SUBJECT: South Boulder Creek Flood Mapping Study Update and Plan for new Floodplain Regulation

Re: South Boulder Creek, Boulder, Colorado
Floodplain Mapping Study Submittal to Update the Boulder County Flood Insurance
Study and Flood Insurance Rate Map

South Boulder Creek, Boulder, Colorado
Hydraulic Analysis and Floodplain Mapping Review Interim Summary
Michael Baker Jr. Inc.
November 2007

Figure 1 – Inflow hydrograph at Eldorado Springs

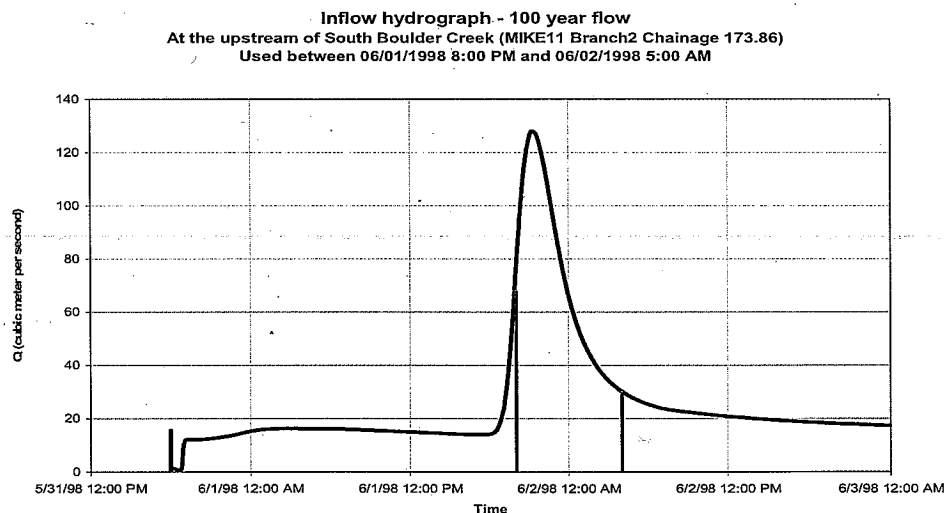
The inflow at the upper modeling boundary of South Boulder Creek, as given in MIKE11 at Branch 2 Chainage 173.86, is shown in Figure 1. The inflow hydrograph lasted 54 hrs from 05/31/1998 6:00 PM through 06/03/1998 12:00 AM. The simulation period of the MIKE FLOOD model begins at 06/01/1998 8:00 PM and ends at 06/02/1998 5:00 AM, shown as truncated by the pink lines in Figure 1. The peak of this inflow hydrograph is captured but the inflow volume is less than the volume of the entire hydrograph.

Use of the truncated hydrograph was discussed with Eric Fontenot of DHI. He explained that the un-routed portion of the hydrograph, representing in-channel flows, does not have a significant impact on the overbank flooding and does not represent the volume that could be stored in the floodplain. As such, the un-routed portion of the rising limb of the hydrograph has little impact on the flood hazards.

We evaluated the travel time of flood waves to verify the methodology. The travel time for the 100-year hydrograph from the upper modeling boundary to the confluence of South Boulder Creek with Boulder Creek, as simulated by the MIKE FLOOD model, is approximately four hours, from 9:15 PM to 1:30 AM of the next day. The nine-hour

The evaluation concluded that the duration of the truncated inflow hydrograph is long enough for the stream to reach the maximum water surface elevation within the channel and in the overbanks.
